**SUBMITTAL TO THE BOARD OF SUPERVISORS
COUNTY OF RIVERSIDE, STATE OF CALIFORNIA**

SUBJECT: REGIONAL PARK AND OPEN-SPACE DISTRICT: Approve Addendum's to Plans and Specifications, Accept the Low Bid, and Award the Contract for the Construction of the Kabian Park Improvements Project; Approve Allocation of American Rescue Plan Act (ARPA) Funds; Authorize the District 1. [\$1,532,670 Total Cost - 100% American Rescue Plan Act (ARPA) Funds]

1. Approve PKARC-271 Addendums No. 1, No. 2, No. 3 to the project bid documents issued prior to the Tuesday, July 9, 2024, opening;

Plotted By: Lico, Michael Sheet Set: Kha Layout: C-200 DEMOLITION PLAN June 25, 2024 04:03:12pm K:\ORA_LDEV\194254101 - Kabian Park Improvements\CAD\PlanSheets\DEMOLITION PLAN.dwg

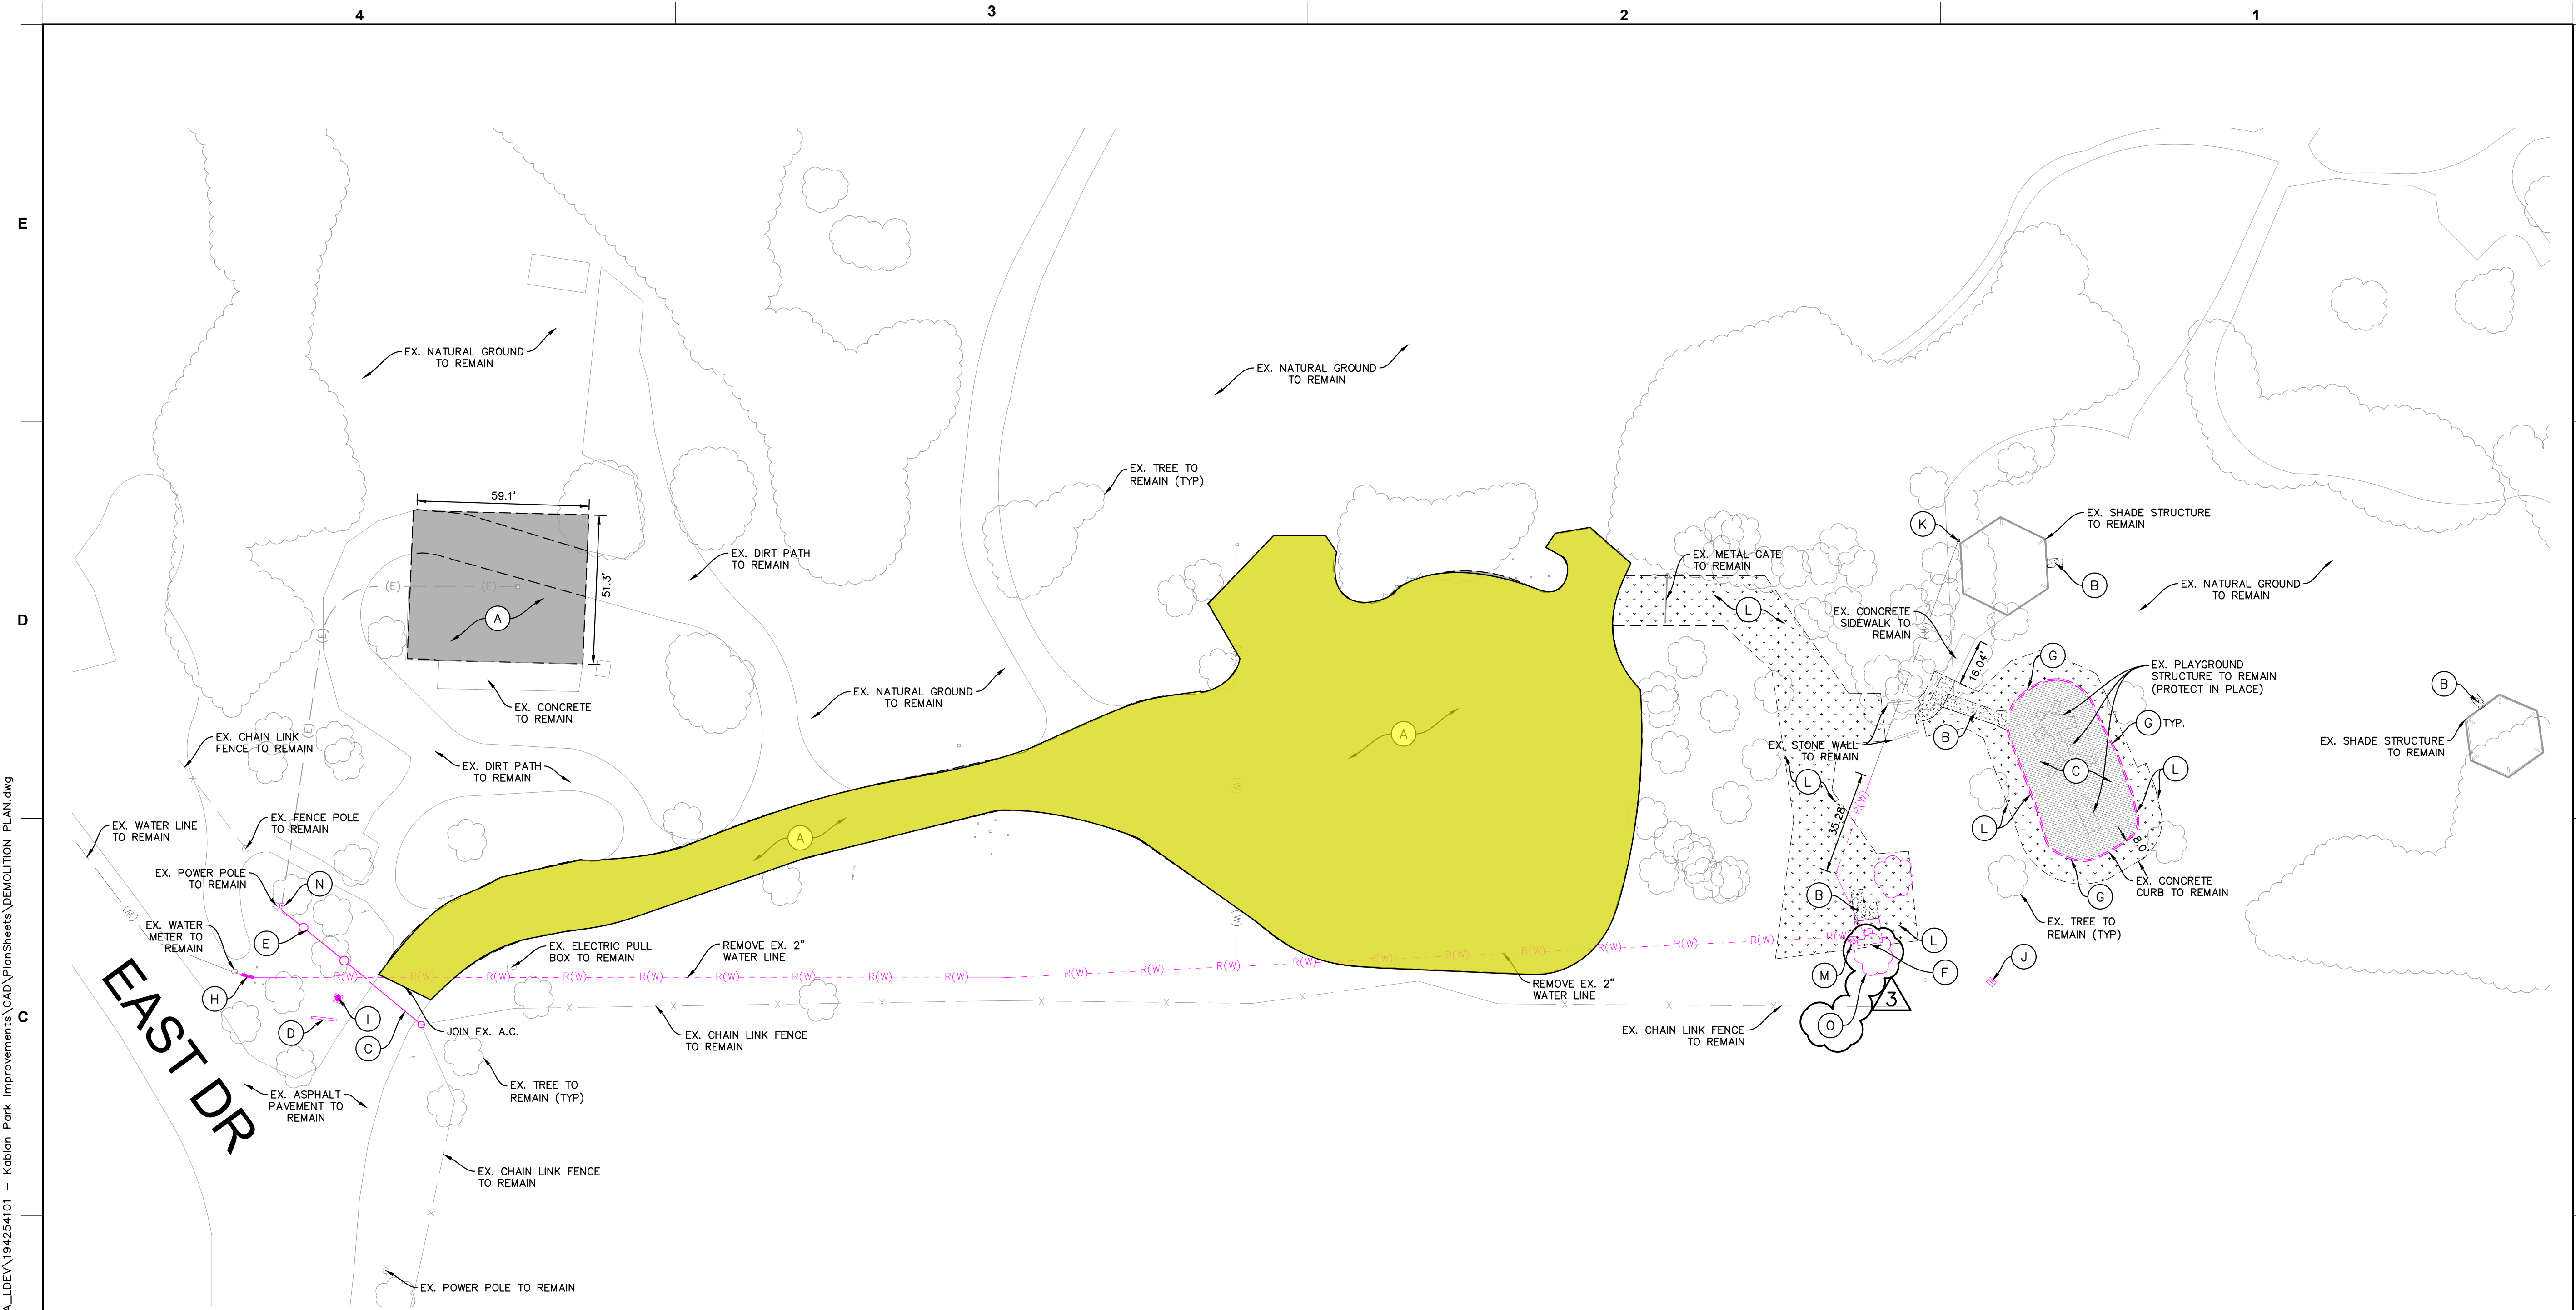
1. **Base Scope addition:** Remove the tree behind the existing restroom building. **Note:** Scope includes covering over the stump to grade with material from the site. See also the revised plan sheet C-200 dated 6-25-24.
2. **Additive Alternate #2 is being added:** The scope of work for Additive Alternate #2 includes the following as per the plans issued herewith:

#	Plan Sheet Full Reference	Change
C-200	Demolition Plan 06/25/24	Modified to include tree removal behind the existing restroom as part of the base bid.
1 of 3	Exh. A – Removable Bollards Plan 06/25/24	Issued in support of new Additive Alternate #2.
2 of 3	Exh. B – Removable Bollard Detail 06/25/24	Issued in support of new Additive Alternate #2.
3 of 3	Exh. C – Existing Culvert Cleaning 06/25/24	Issued in support of new Additive Alternate #2.

Printed By: Lion, Michael Sheet Set: Ksho Layout: C-301 CONSTRUCTION PLAN June 26, 2024 03:09:39pm K:\VRA_LDC\194254101 - Kabian Park Improvements\CAD\PlanSheets\CONSTRUCTION PLAN BID ALTERNATE 2.dwg

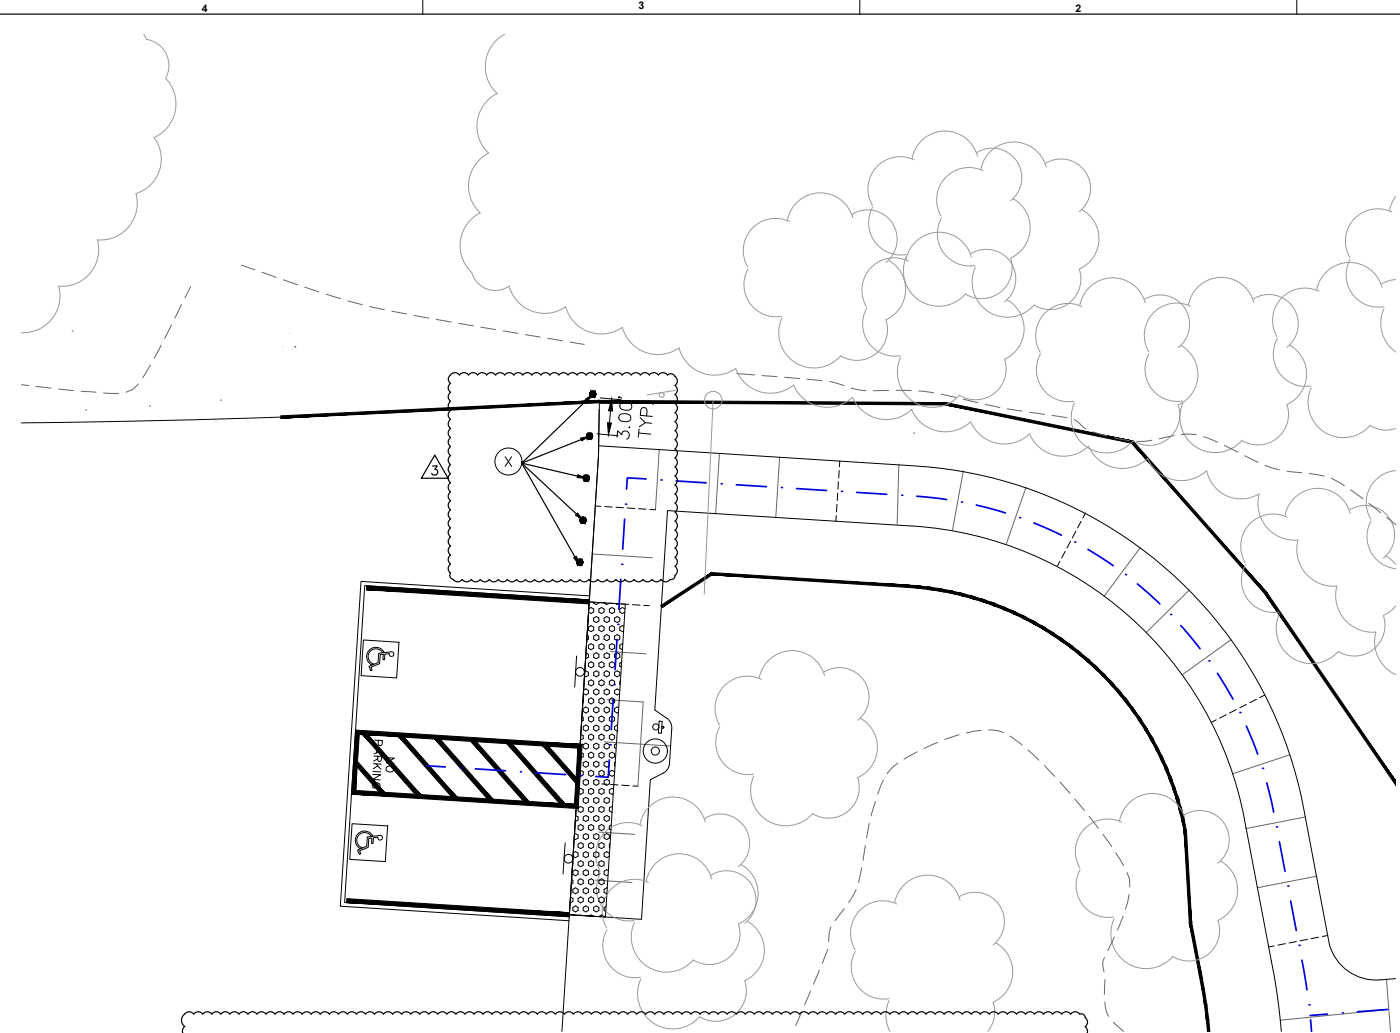
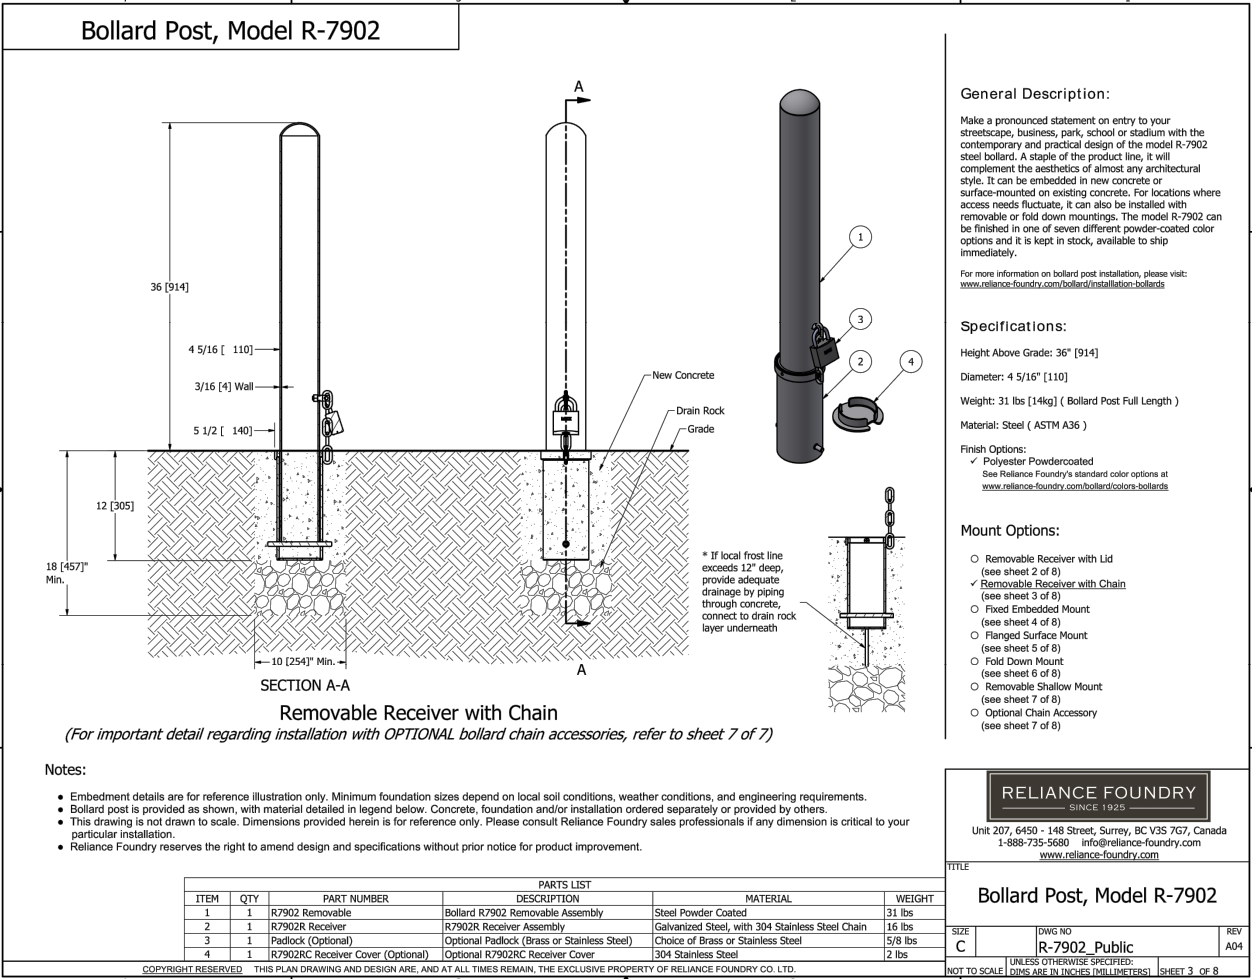
- a. Provide FIVE (5) removable bollards of the type and at the locations as shown on Exhibits A & B – Removable Bollards per new plan sheets 1 of 3 and 2 of 3 dated 6-25-24.
- b. Provide work to clear FOUR (4) existing storm drain culverts and provide some amended decomposed granite surface to the small pedestrian path where the path goes over the storm drain to cover where the storm drain has become exposed. Locations and further description of the scope of work as shown on Exhibit C – Existing Culver Cleaning new plan sheet 3 of 3 dated 6-25-24.
